REV	DETAILS	INIT.	DATE
B	Amend following planning meeting	CG	07.09.2023
A	Material confirmation from client.	SCB	15.12.2022
TITLE Conversion of Existing Barns to Residential, Northdale Park, Raunds, Northamptonshire. Elevation View F and H; Existing, Approved, Variation - Proposed.			
SCALE	1:100	SHEET	A1
DRAWN	SCB	CHECKED	22-036-155B
DATE	December 2022	ISSUE	PRELIMINARY

**Variation - Proposed Elevation F**  
*(Internal courtyard)*  
Scale 1:100

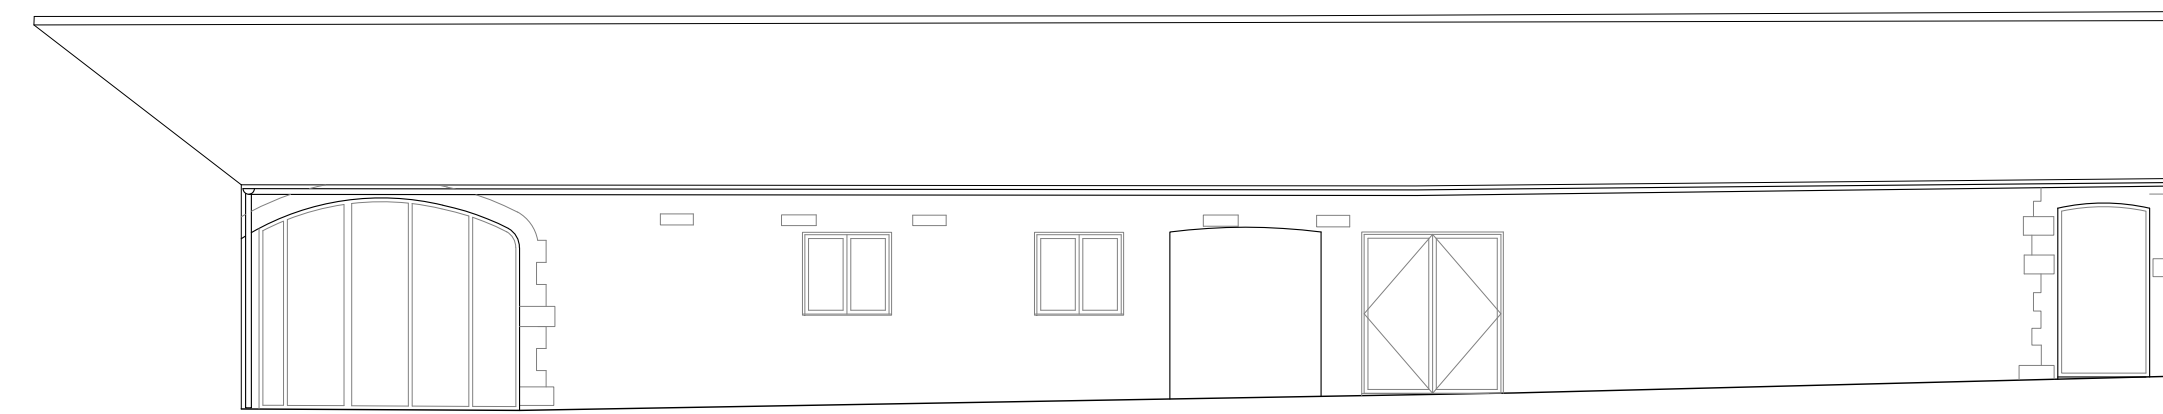
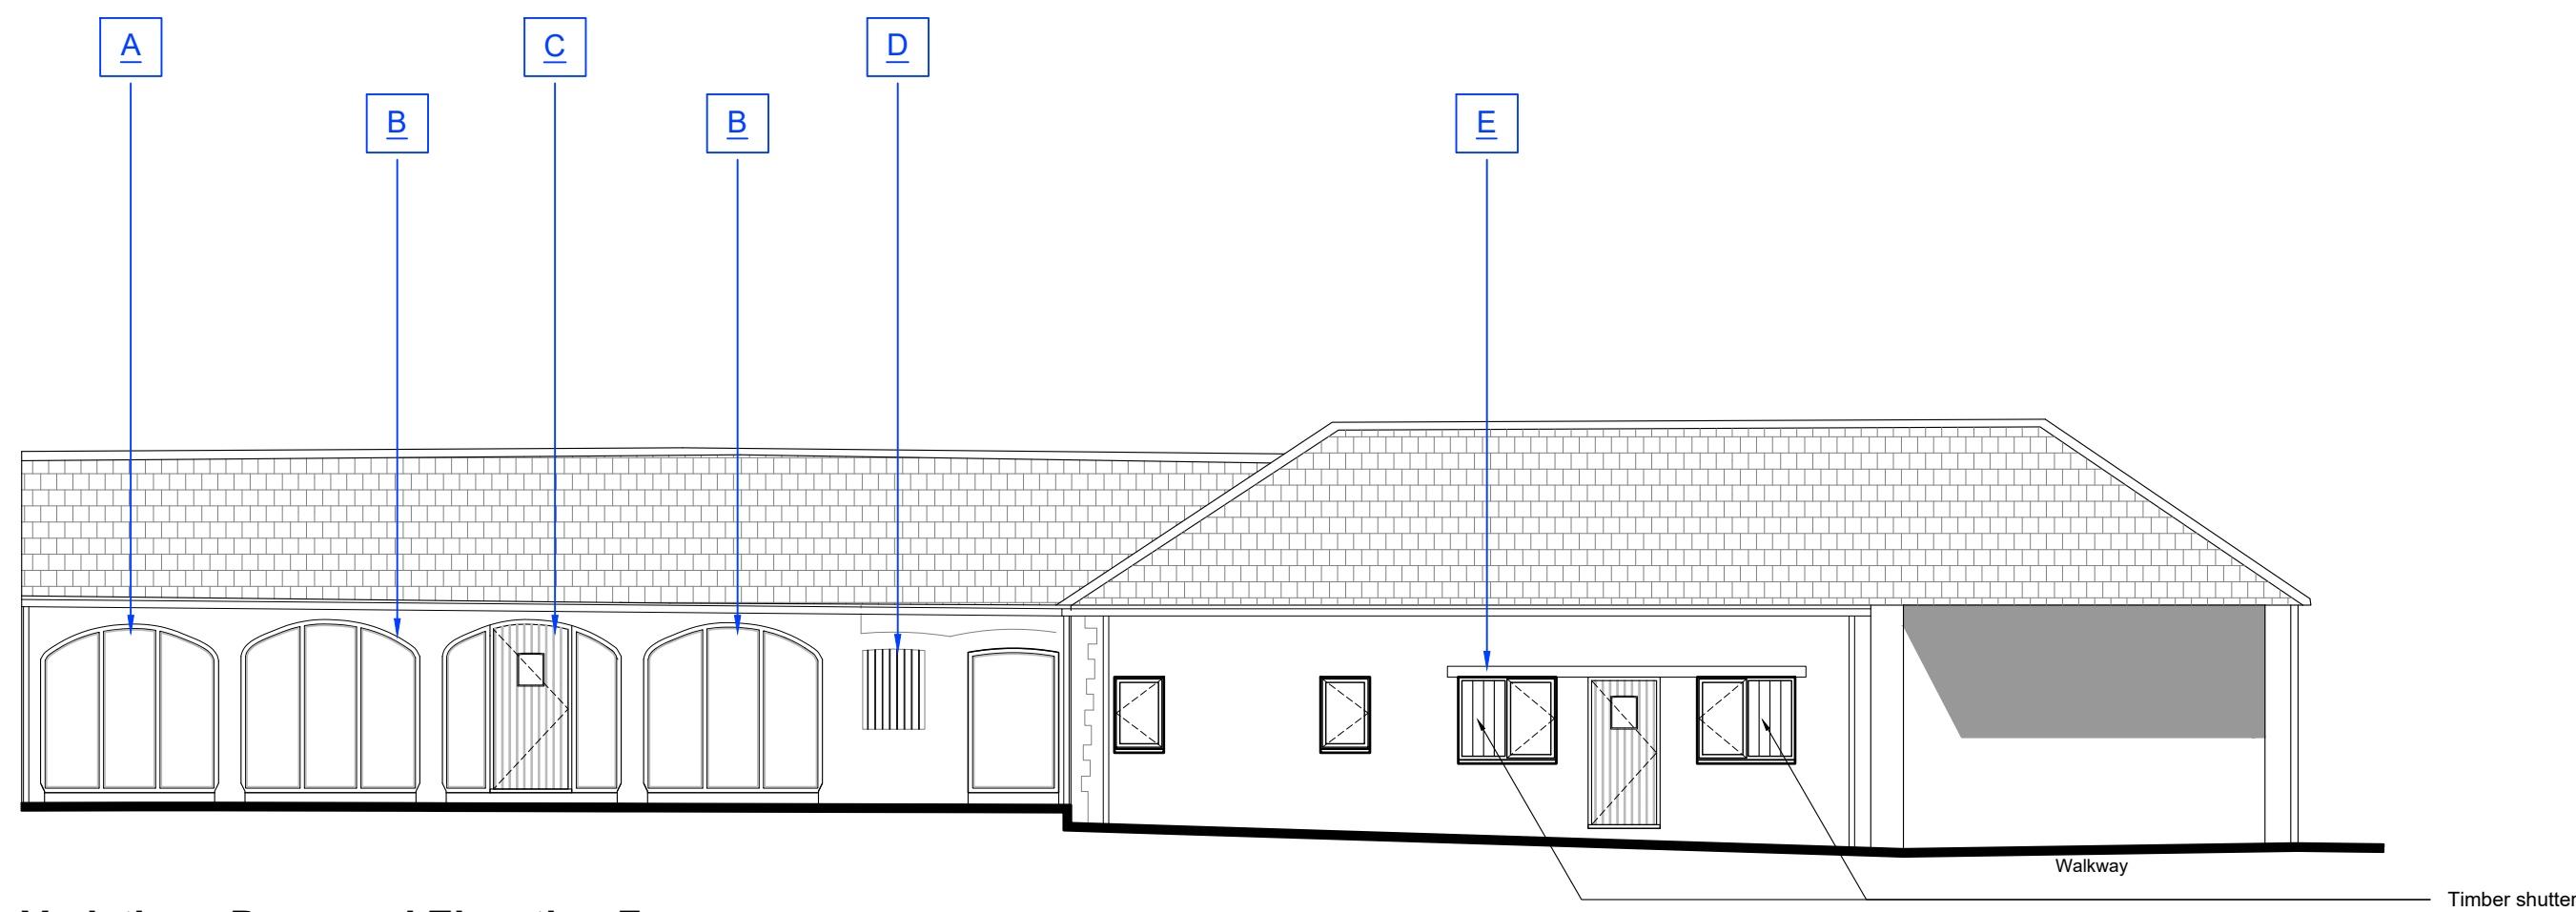
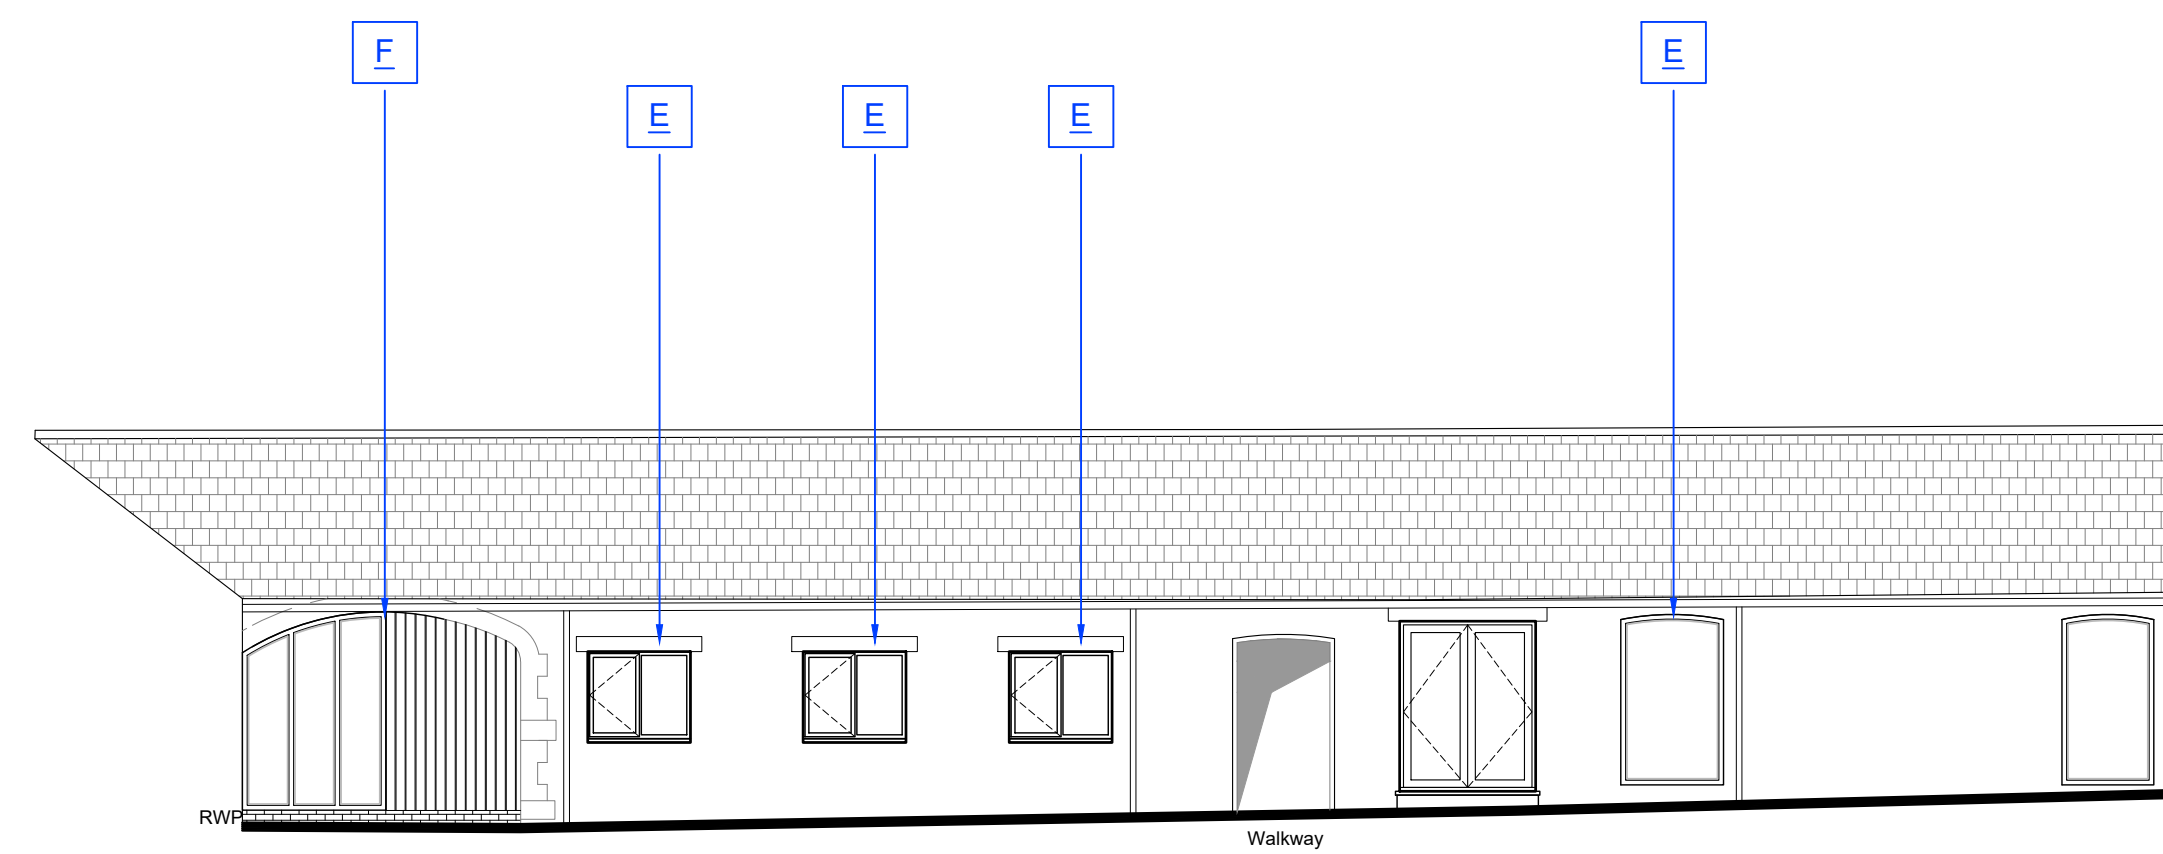
<p><b>A</b> Variation - Door removed proposed glazing panels adjusted. Justification - To reduce excessive entry points into units, improve privacy and security and maintain featured arch.</p> <p><b>B</b> Variation - Glazing sizing and panelling revised. Justification - To be more in keeping with the proposed aesthetics.</p> <p><b>C</b> Variation - Entrance door and adjacent glazed panels position and sizing revised. Justification - To be more in keeping with the proposed aesthetics.</p>	<p><b>D</b> Variation - Existing structural opening to be suitably infilled and finished externally with cladding. Justification - No need for additional glazing into this habitable space. Use of cladding is a sympathetic material complementing the character of the building.</p> <p><b>E</b> Variation - New windows to be installed. Justification - To provide good levels of natural daylight and/or ventilation.</p> <p><b>F</b> Variation - Proposed glazing reduced and remainder of existing structural opening infilled and finished externally with cladding. Justification - To reduce vast amounts of glazing, effecting thermal performance of the unit and increase privacy into the unit.</p>

Elevation F  
Number of openings in wall on original approval = 8  
Number of openings in wall on proposed application = 10

Elevation H  
Number of openings in wall on original approval = 6  
Number of openings in wall on proposed application = 8
